TO ALL OUR CUSTOMERS

1. NEWS: NEW 20-32-40A THERMOPLASTIC ENCLOSURES FOR THE ISOLATORS SERIES

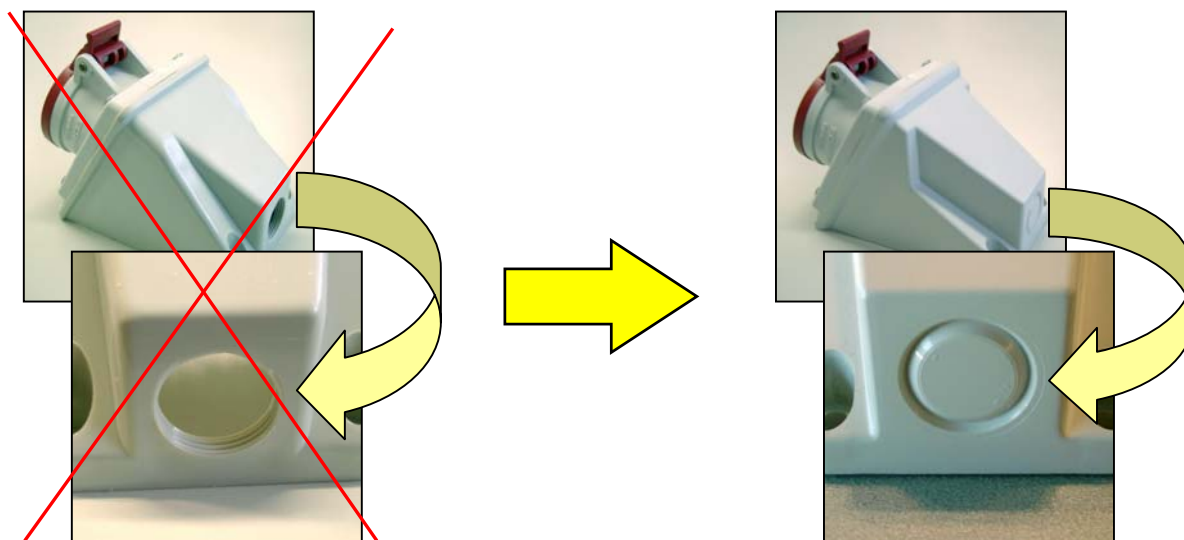
The thermoplastic ISOLATORS series offer has been expanded, introducing a range of products for 20, 32 and 40A switches. Substantially a new casing has been created having smaller dimensions with respect to the current casing, which however remains normally in production.

The dimensions of the new casings conform to those of the 20, 32 and 40A metal version.

Dimensions of the new casing: 105x150x82mm.

The entrances are knock out type: 1xM20 + 1xM25 (both on the upper as well as lower sides).

The IP degree of protection of the new casing is identical to that of the versions currently in production: IP65.

8. PRODUCT MODIFICATION: NEW MEMBRANE FOR METRIC AND PG CABLE GLANDS

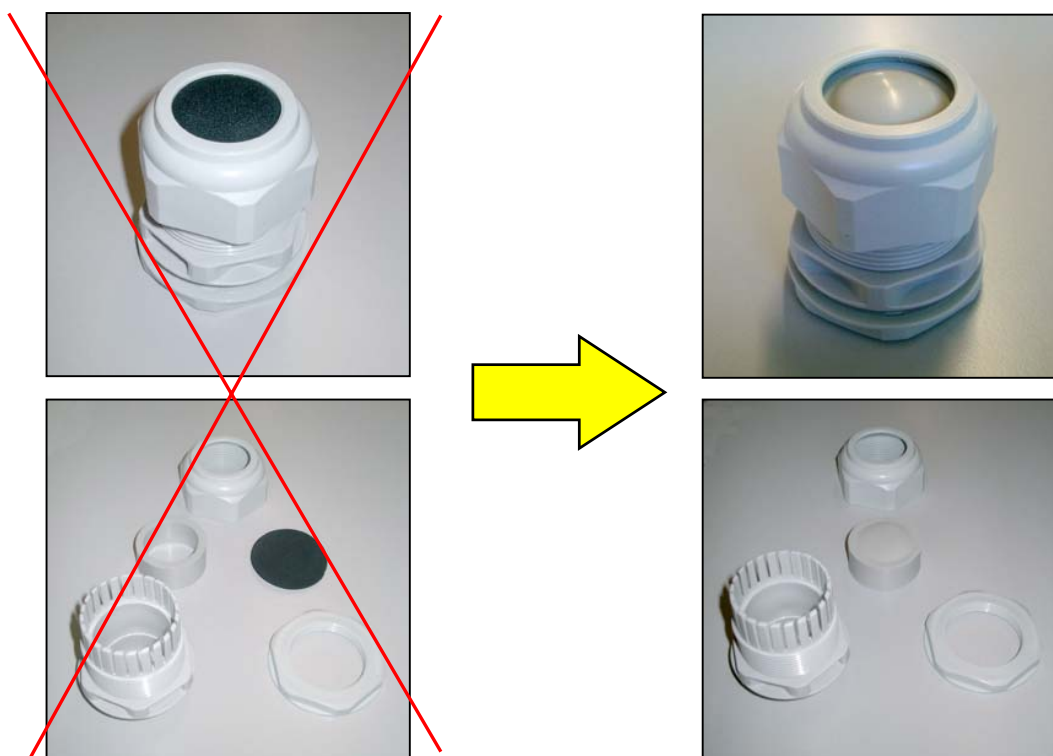
The gasket of the membrane cable glands has been modified: the membrane will no longer be independent, but is realized in a manner integral with the gasket of the cable gland. The membrane is easily pierceable by cables or tubes.
